HISTORIC PRESERVATION MEETING ZEPHYRHILLS, FLORIDA

**Thursday, January 19, 2023
6:00 PM**

Staff Report

To: Historic Preservation Board
From: Audrey McGuire, AICP
Re: 3854686th Avenue – Request for COA (Accessory Structure)
Date: January 19, 2023

PLANS

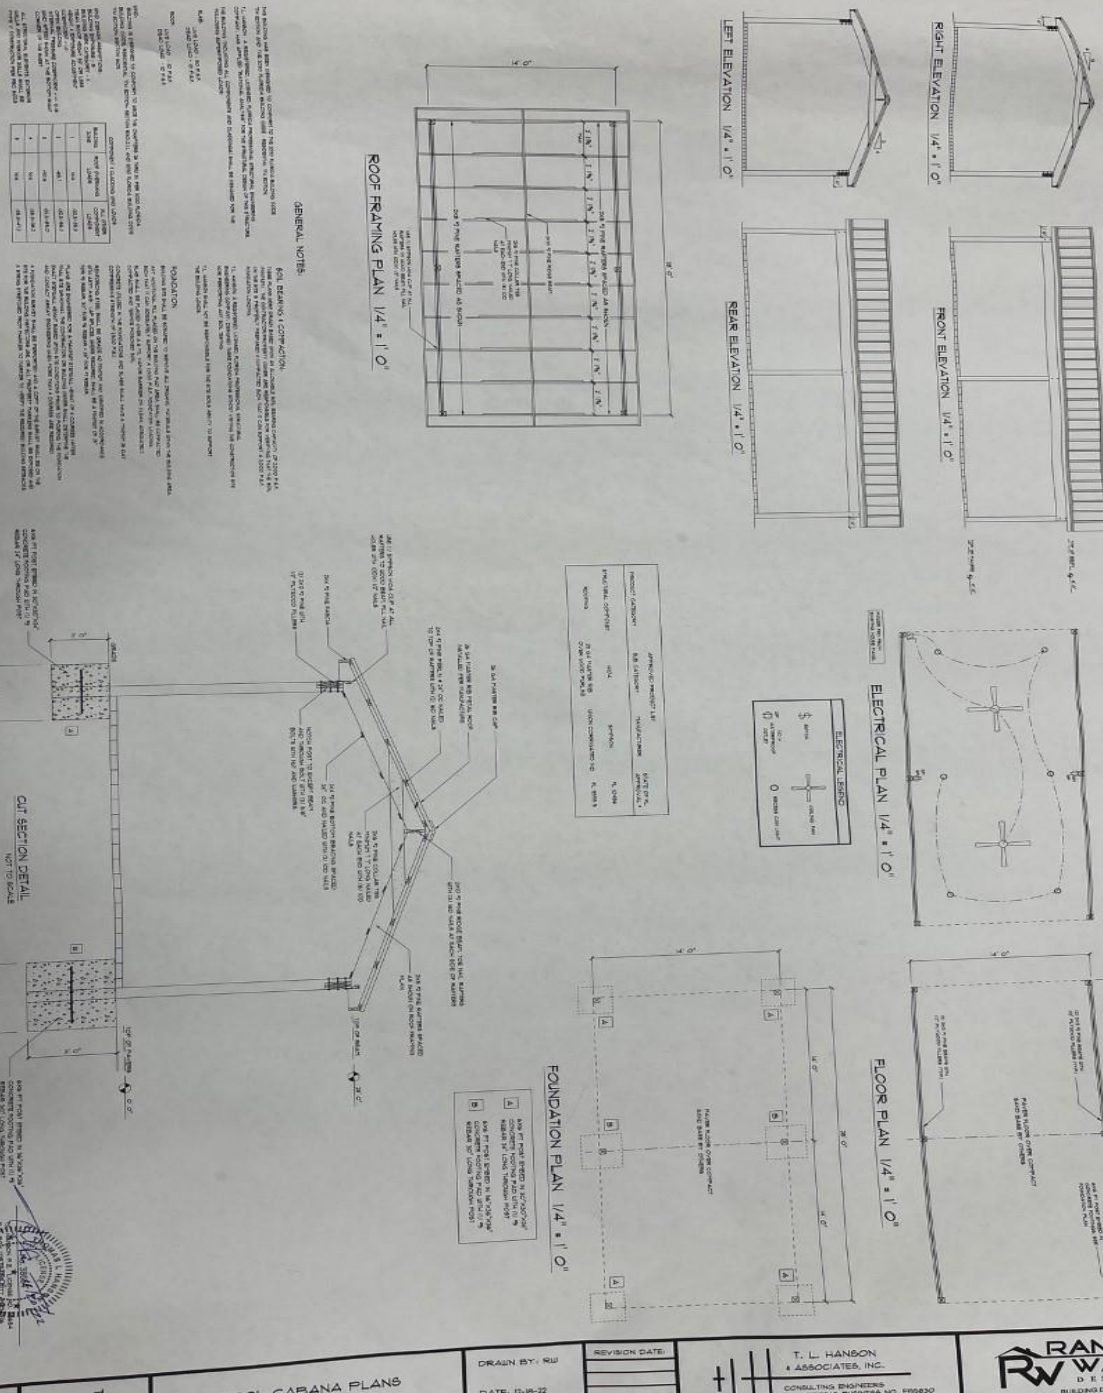
The applicants are requesting to install at 14' x 28' pool pavilion (open sides). The pavilion is to be constructed of wood and roofing material will be 5v-crimp metal to match the existing primary residence.

- STAFF ANALYSIS: The proposed accessory structure will be constructed of wood and clad with a 5v-crimp metal roof, consistent with the building materials of the primary historic structure, and in character with the surrounding area.

- i. The proposed structure is approximately 15% of the total square footage of the primary structure (residence) and is proposed to be 10 feet, 6 inches in height and therefore complies with this LDC requirement.

- i. The proposed accessory structure is to be located on the same parcel as the primary structure and is proposed to be setback from the side (west) property boundary line by 5 feet, and the rear by 12 feet, meeting the locational standards prescribed above.

- i. The proposed accessory structure is to be of wood-frame construction and feature the same roofing material/design as the primary structure, meeting the design standards of the LDC stated above.

The proposed construction of an accessory structure (pool pavilion) is in conformance with historic design guidelines for new construction, as well as the city's Land Development Code pertaining to accessory structures. Staff recommends approval of a certificate of appropriateness for the installation of roof-mounted solar energy system at 38548 6th Avenue, as presented.
